DEVELOPMENT CONSENT AUTHORITY PALMERSTON DIVISION

AGENDA ITEM: MEETING DATE: 14 March 2025 FILE: PA2023/0324

APPLICATION PURPOSE: Variation to condition 5 of DP23/0304 for the purpose of

SUBJECT SITE: Units 13888 & 13892, 11 Tarakan Court, Johnston, Town

Bookmark B2 updated drawings (received 10/03/2025)

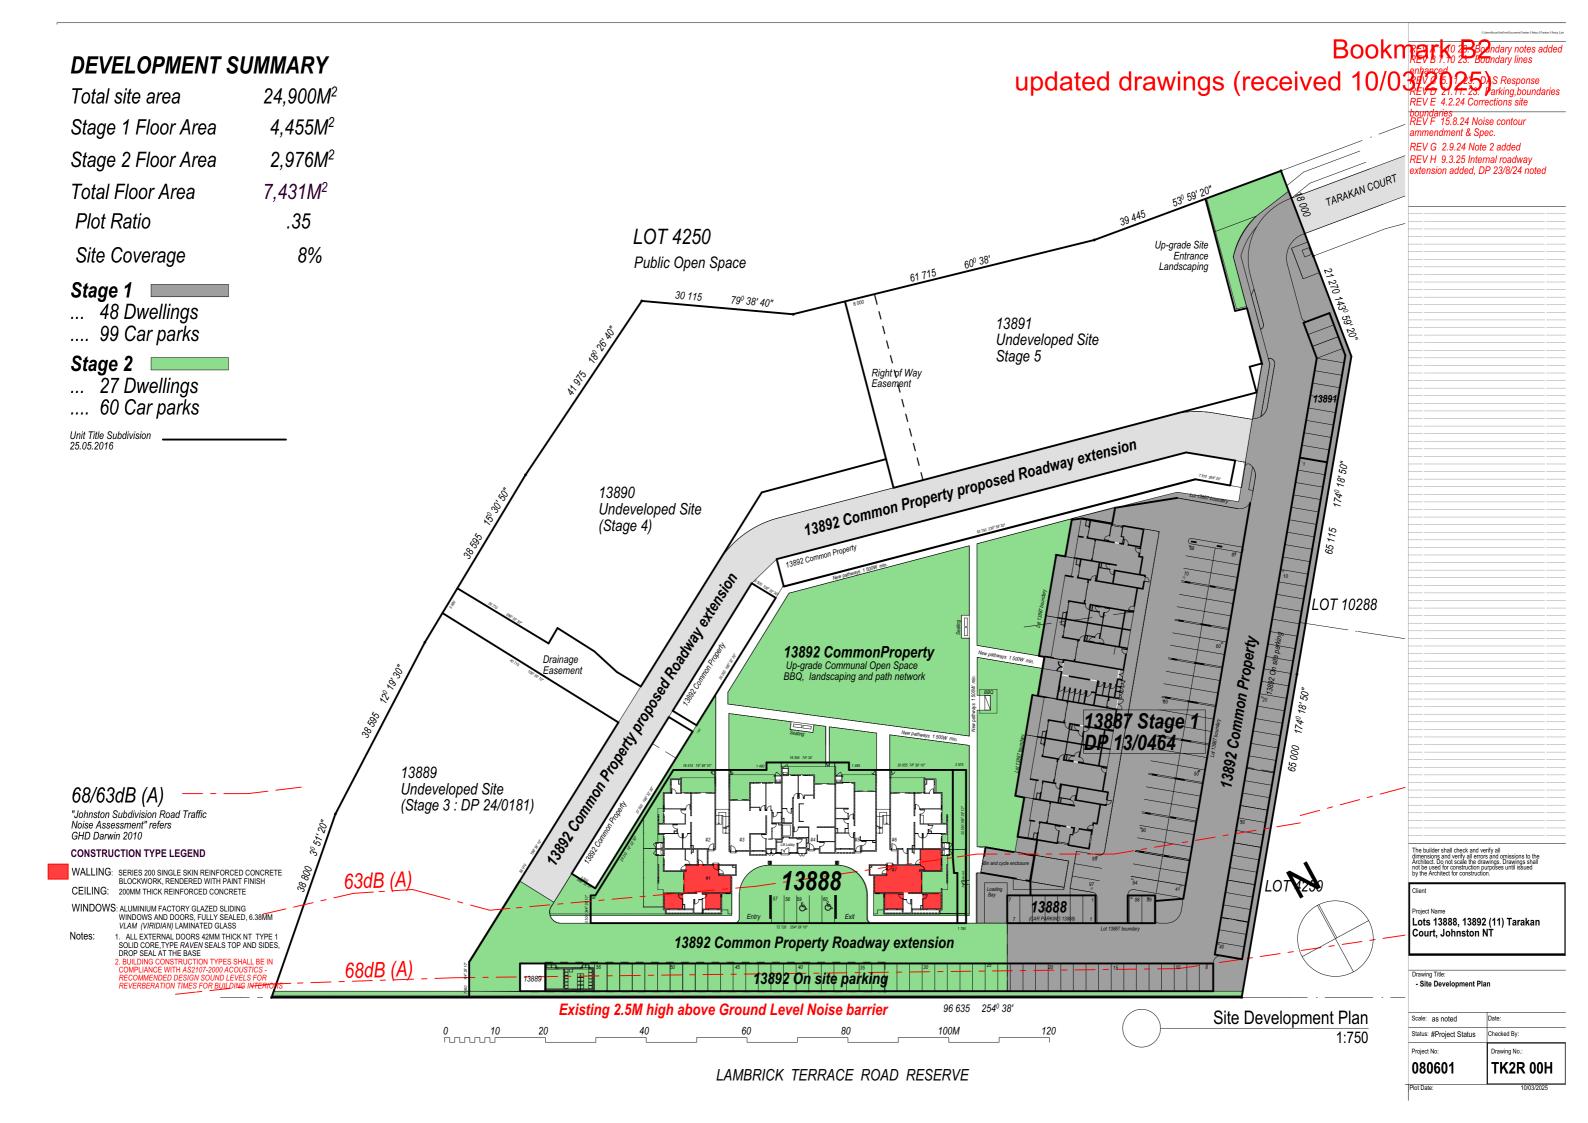
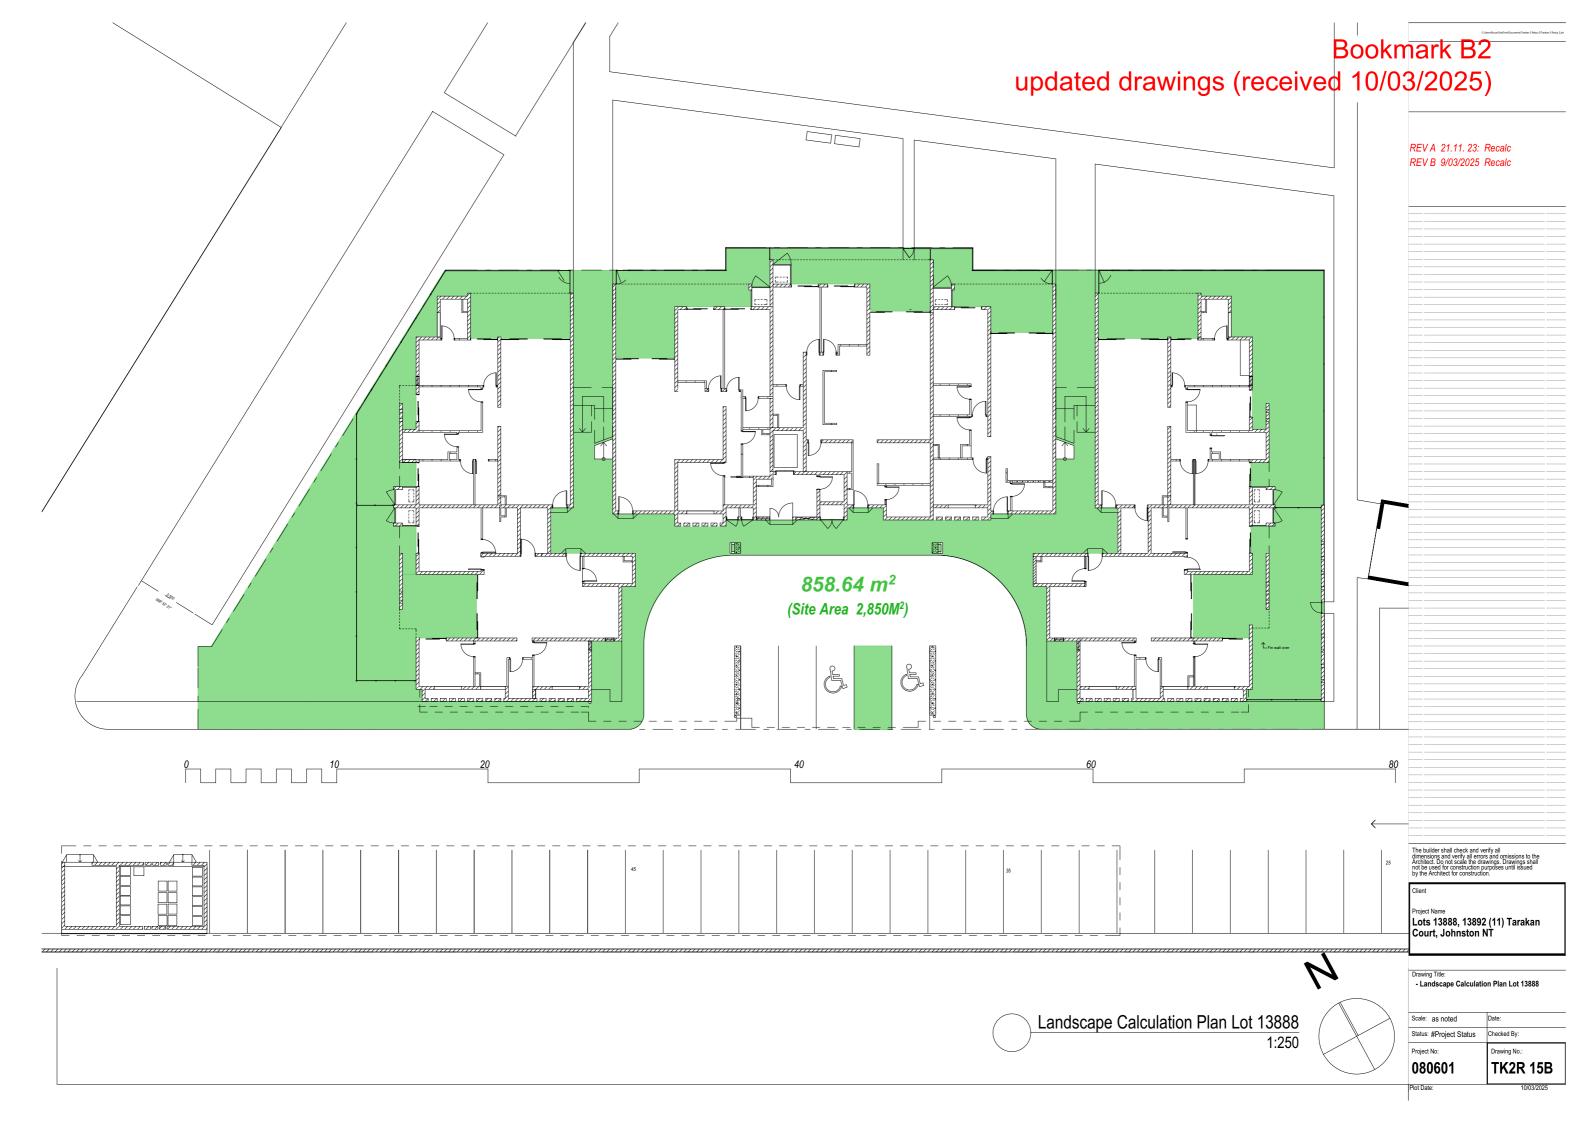
5.4.6.2 (Private Open Space for Dwelling-Multiple)	The 2025 variation application drawings show • changes to private open space (ground level and balconies)	To be determined – may be less than a 5% change.
	 updated drawings (Bookmark 2) indicate areas (m²) of balconies and ground level private open space comply no calculations (confirmation of 2.8m dimensions) have been provided. Fencing at ground level will be 1.8m high Direct access from ground level private open space to communal open space provided. 	Areas (m2) reduced for some dwellings (from what was approved by DP23/0304), but design complies with NTPS2020.

5.4.8.2 (Building Design for Dwelling- Multiple)	Design approved by DP23/0304 granted variations to the balcony designs Drawings (Bookmarks B1 and B2) do not provide commentary / dimensions regarding balcony compliance (sub-clauses 13 and 14). 2025 changes to drawings includes amendments to balcony	To be determined – may be less than a 5% change.
	designs / m ²

Drawing Title:
- 2nd Floor Plan: Private Open Space
2nd Floor Plan: Private Open Space

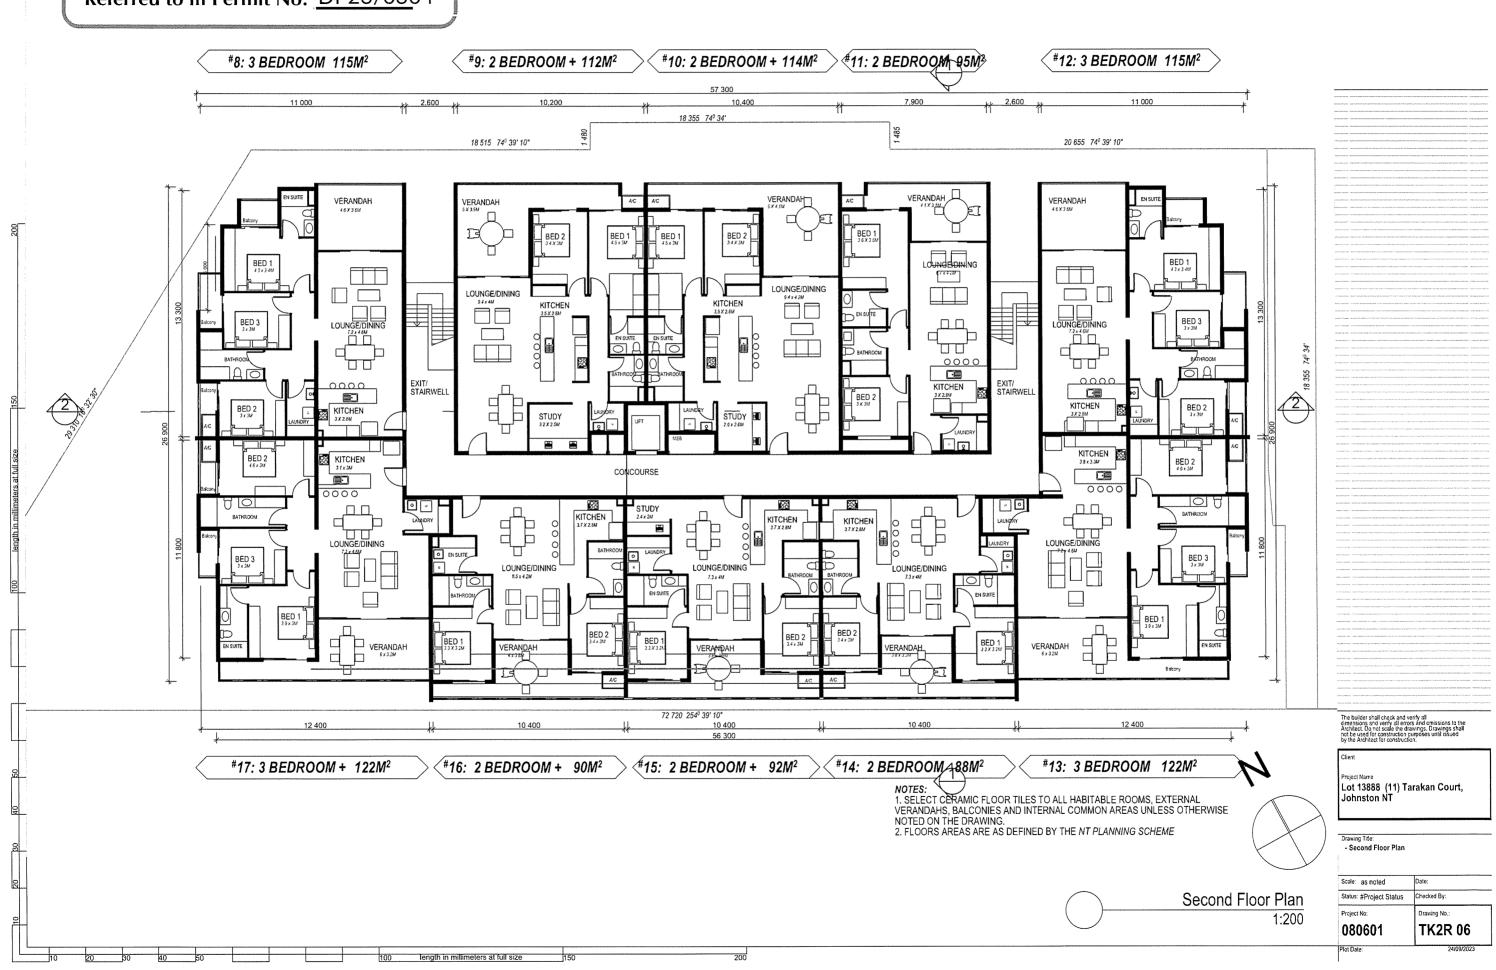
5.2.6.1 (Landscaping in Zones Other Than Zone CB)	The calculation of "landscaping" for the drawings for DP23/0304 was 4575m² (36% area of the Units 13888 & 13892). The NTPS2020 requires 30% of a "site" area. The updated drawings (Bookmark B2) included with the variation application provide overall calculations of landscaping however, locations of planted areas /	 Will comply with NTPS2020 Changes unlikely to be greater than 5%. Variation of Conditions permit should either refer back to endorsed landscaping drawing 2023/0324/06 or require an

TK2R 15B: Landscape Calculation Plan lot 13888
